STAFF REPORT

AGENDA ITEM: **Variance – Direct Access for a Place of Worship**

CARMELITE MONASTERY DRIVEWAY FINAL GRADING UTILITY & STREET CONSTRUCTION PLAN LAKE ELMO, MINNESOTA

To:	Ken Roberts, Planning Director	Re:	Carmelite Monastery Driveway
Cc:	Marty Powers, Public Works Director Chad Isakson, Assistant City Engineer		Engineering Construction Plan Review
From:	Jack Griffin, P.E., City Engineer

1.3 OF 18

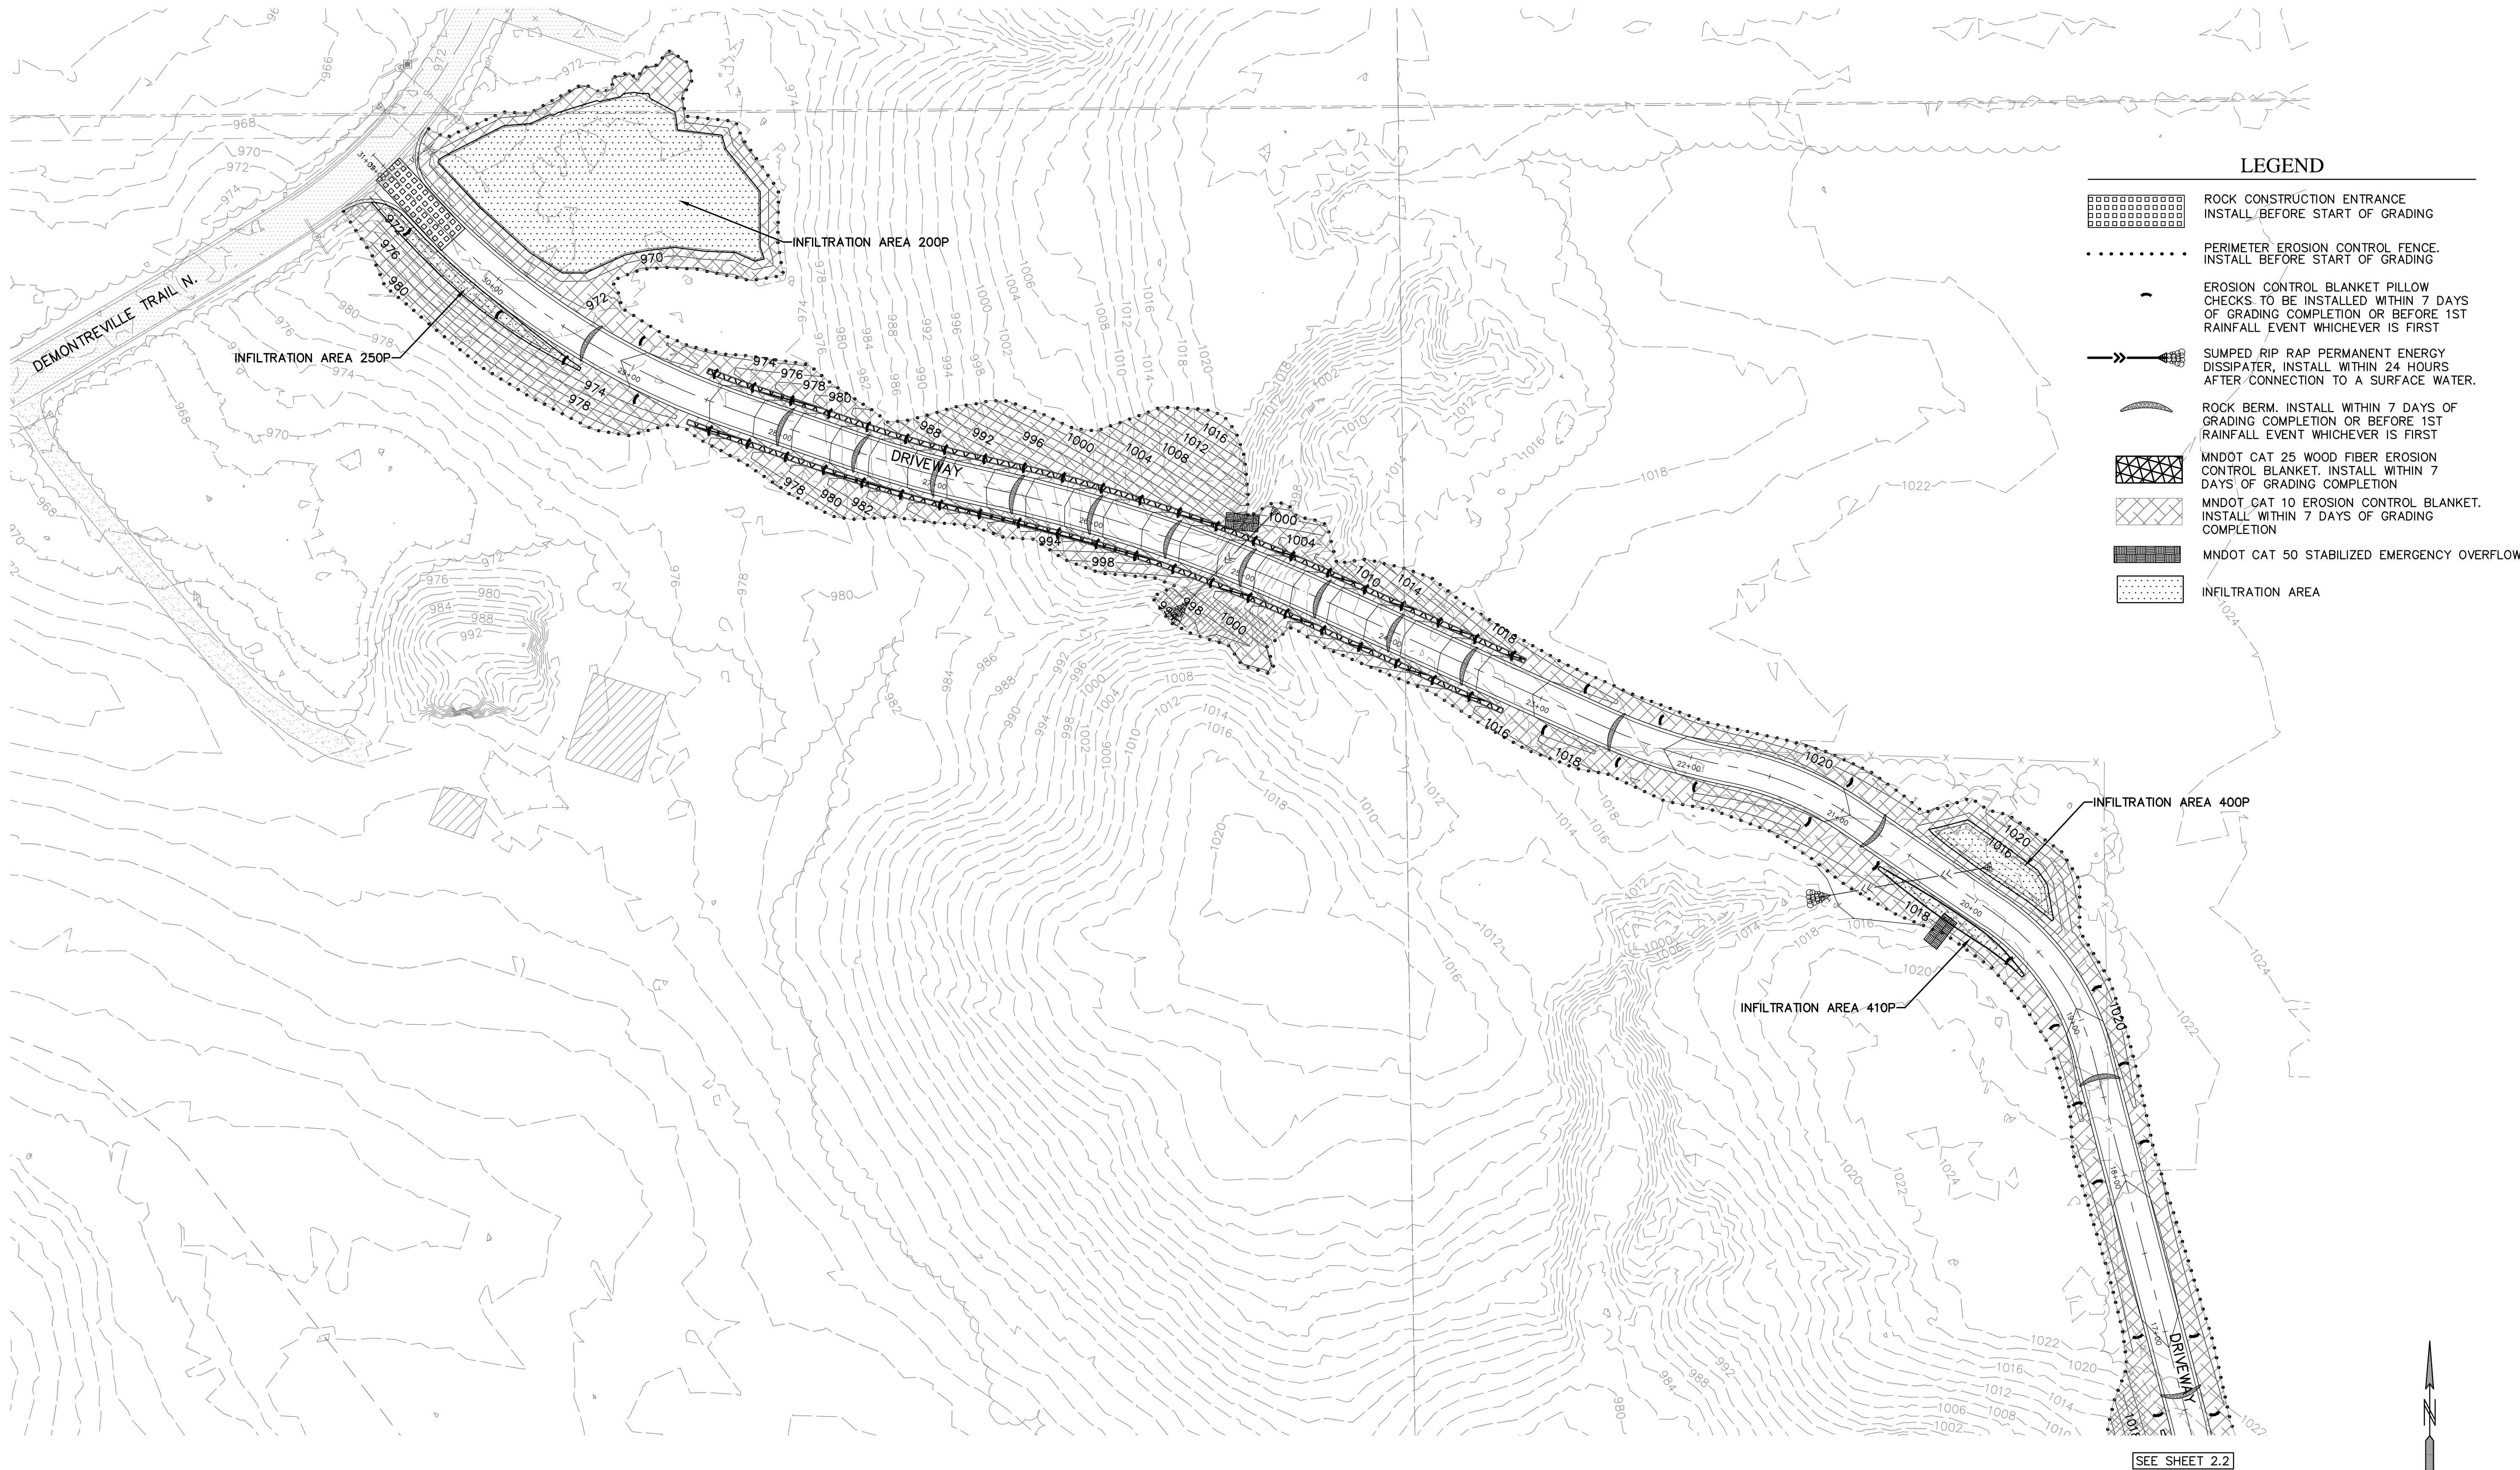
6. Sheet 1.1 – 1.3. Add culvert pipe size, material, and invert for all proposed and existing culverts.
7. Sheet 1.1 – 1.3. Add the 100-year HWL elevation and contour for all proposed infiltration basins. Add emergency overflow elevations and flow paths.

8. Sheet 1.1 – 1.3. Add proposed drainage and utility easements for each infiltration basin, incorporating the 100-year HWL elevation and contour, and maintenance access routes to all drainage structures.

9. Sheet 1.1. Revise grading plan to eliminate infiltration basin encroachments for areas 200P and 250P from the DeMontreville Trail right-of-way. Revise plans as needed to ensure the EOF flow path from 200P and 250P remain outside of the public right-of-way.
